Your Case Number: **APC 324156-26**
Our Ref: Obs 1

Observation by
Cahermurphy Area
Community Group
in response to
Cahermurphy Renewables
DAC Application
ACP-324156

Observation by
Cahermurphy Area
Community Group
in response to
Cahermurphy Renewables
DAC Application
ACP-324155

Chapter 12 Noise and Vibration

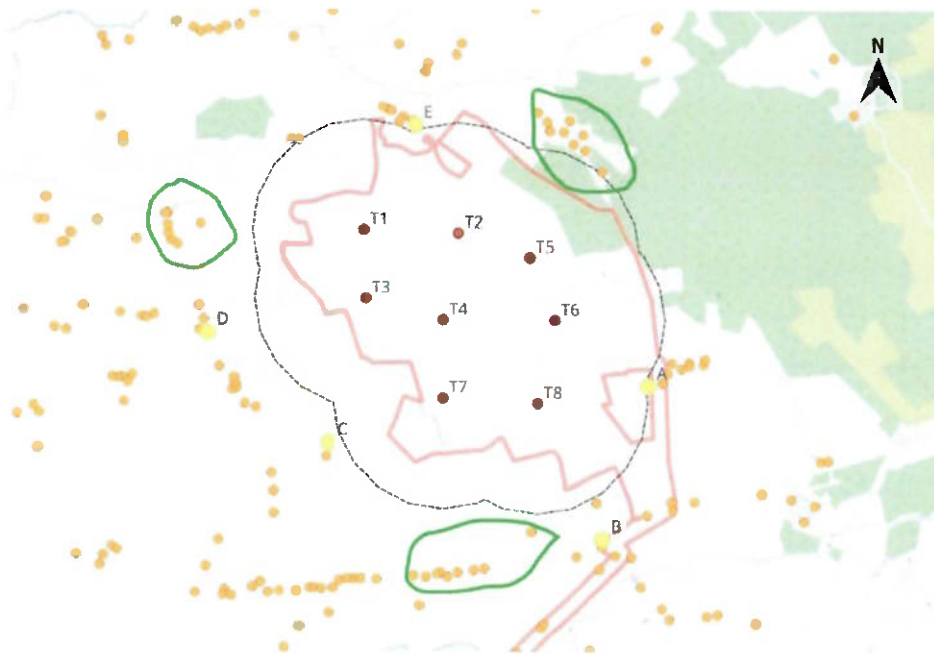
We have already made our views on audible and inaudible sound, and the effects they might have, clear when we discussed the issue under Chapter 5, Population and Human Health and will not repeat them here. We find it encouraging in the section on the fundamentals of acoustics that the developer has acknowledge the existence of sound outside the audible range and makes it clear that the dBA weighting has been developed solely to measure audible sound.

When considering the study area for assessing the potential noise impact we are referred to Appendix 12-2, where a list of operational, awaiting planning and pre-planning wind farms are given. Once again, we must make the point that several, including some currently in the planning system, seem to have been omitted. These include Illaunbaun Wind Farm (currently at ACP), Slievenalicka Locally-owned Turbine (currently at Clare County Council), Dehomad (pre-planning) and Crag (pre-planning).

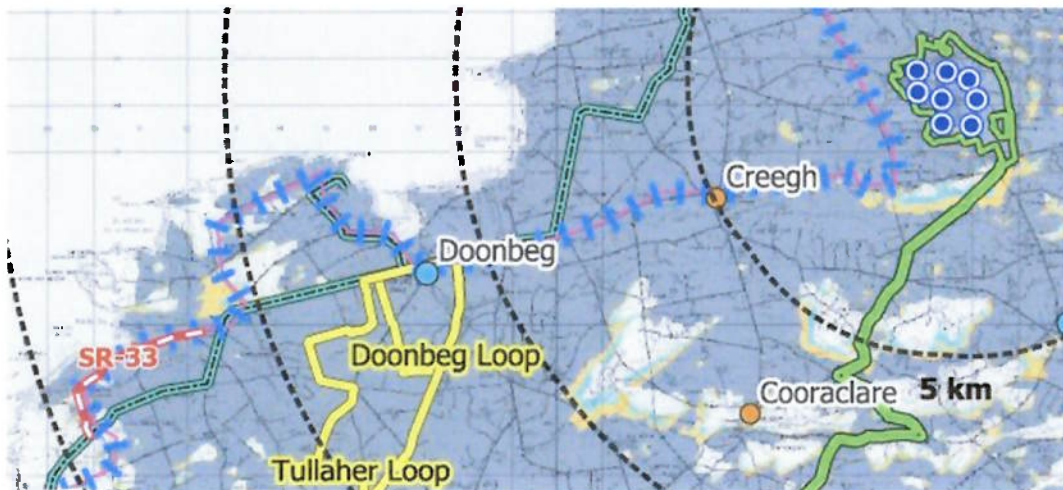
In terms of height we cannot agree that such industrial turbines would appear appropriately scaled within the surrounding landscape. We believe that, in conjunction with the differing heights and the various rotor blade dimensions and rotational speeds involved in the existing Cahermurphy Wind Farm, the turbines proposed would add further confusion to an already complex skyline from all directions.

We note that three LCAs are scoped out of the assessment and this is of particular concern as the proposed grid connection route runs through the Shannon Estuary Farmlands, one of those scoped out.

Additionally, we are told that the Cliffs of Moher and Lahinch have no actual visibility and whilst this is true for a 15km radius it ignores the fact that the ZTV indicates the possibility of clear visibility from a greater distance in this LCA as evidenced by photomontage 6, a section of which is shown below.
